# UNITED STATES PATENT AND TRADEMARK OFFICE

APPLICATION NO.	FILING DATE	FIRST NAMED INVENTOR	ATTORNEY DOCKET NO.	CONFIRMATION NO.
10/643,267	08/19/2003	Takahiro Imamura	2500.68258	4628

<b>Office Action Summary</b>	Application No. 10/643,267	Applicant(s) IMAMURA ET AL.	
	Examiner Mark Blouin	Art Unit 2653

**Detailed Action**

EXAMINER'S DRAWING

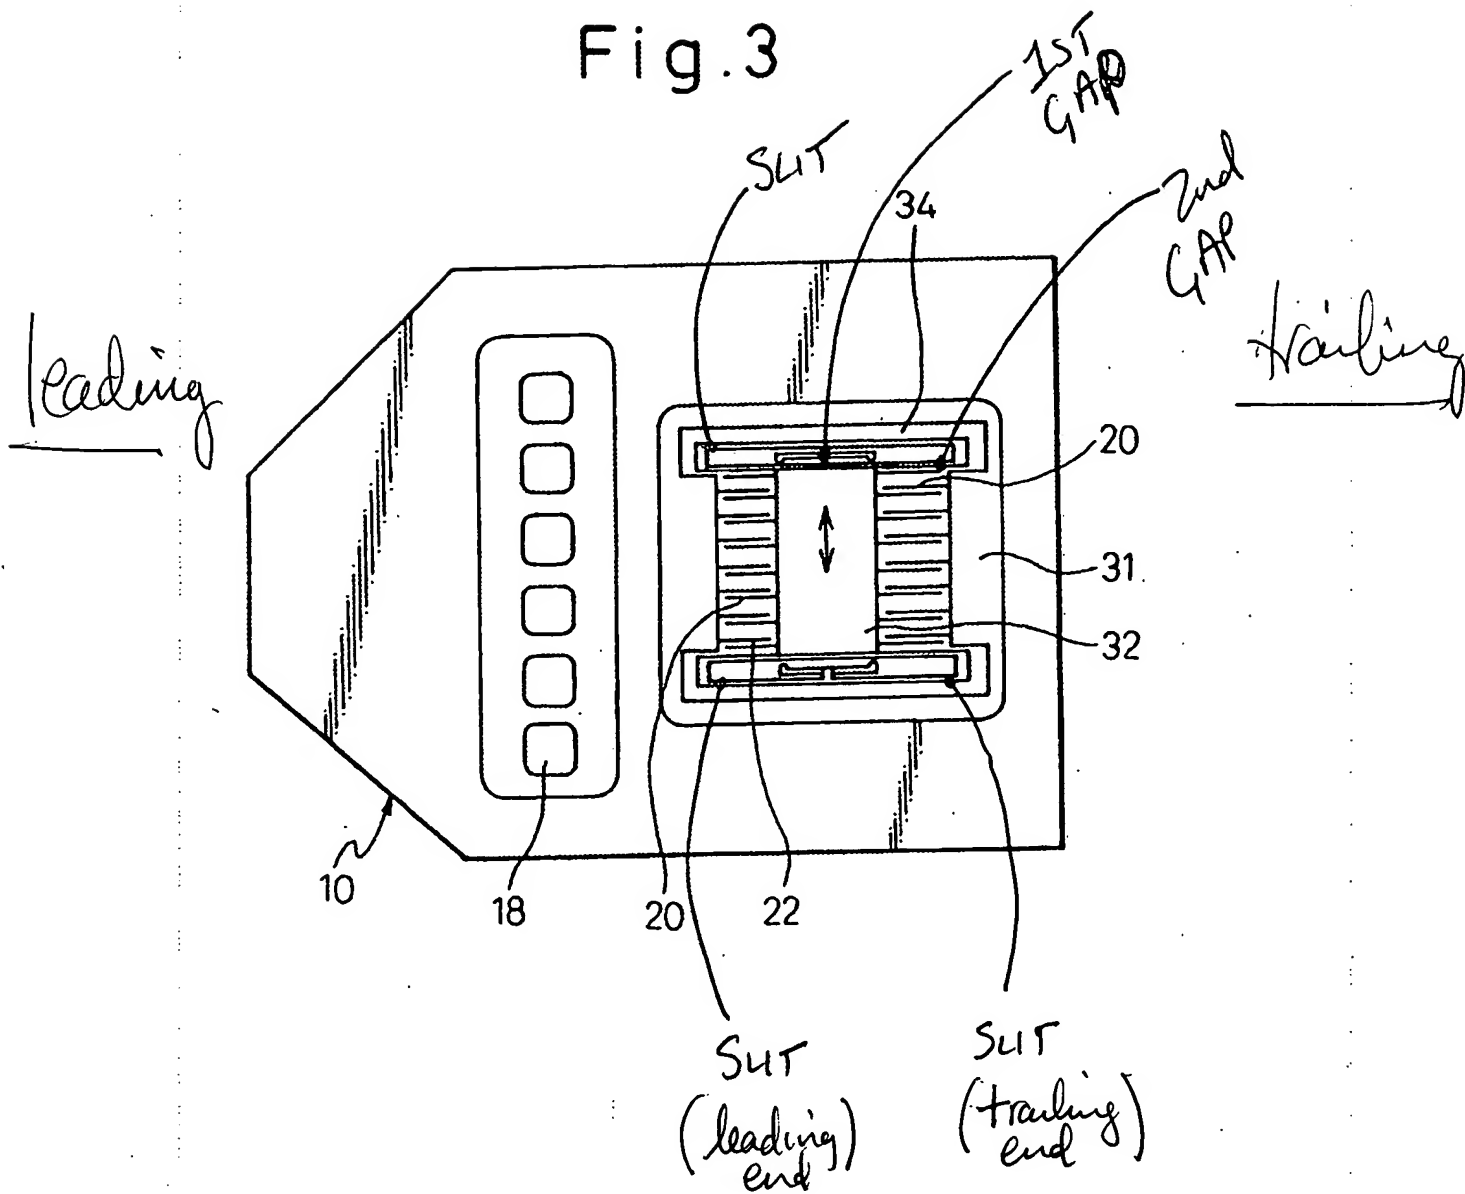
2. Claims 1-16 are rejected under 35 U.S.C. 102(b) as being anticipated by Imamura (USPN 6,359,752).
3. Regarding Claims 1 and 16, Imamura shows (Figs. 3-5), a head assembly comprising, a head suspension (30), a slider body (10) mounted on the head suspension, a slit (See Examiner's Drawing) defined in a trailing end surface of the slider body, the slit extending from a trailing end of the slider body toward a leading end of the slider body, a movable block (32) at least partly spaced from a stationary block (42) of the slider body by the slit, and a head element (43) mounted on a trailing end surface of the movable block.

13. Regarding Claim 11, Imamura shows (Figs. 3-5), the head slider, comprising another slit defined in the trailing end surface of the slider body, the other slit extending from the trailing end of the slider body toward the leading end of the slider body, wherein the movable block (32) is defined between the slits (see Examiner's Drawing).

16. Regarding Claim 14, Imamura shows (Figs. 3-5), the head slider, wherein the void includes a first gap extending between the slits so as to define a leading end of the movable block, and a pair of second gaps extending from opposite ends of the first gap toward the trailing end of the slider body, respectively, in parallel with the slits, the second gaps ending at positions spaced from the trailing end of the slider body (see Examiner's Drawing).

17. Regarding Claim 15, Imamura shows (Figs. 3-5), the head slider, wherein the second gaps extend from the opposite ends of the first gap toward the leading end of the slider body, respective, in parallel with the slits (see Examiner's Drawing).

*"In the Office Action, the Examiner identifies a slit in FIG. 3 of Imamura as corresponding to the slits 35 of the present invention. However, the slit identified by the Examiner is not at the trailing end surface of the slider body..."*

The Examiner maintains that the slit shown in the Examiner's Drawing clearly extends from the leading end to the trailing end on the slider body, and that part of the slit is considered to be at a trailing end surface. Therefore, the rejection of Claims 1-16 are upheld.
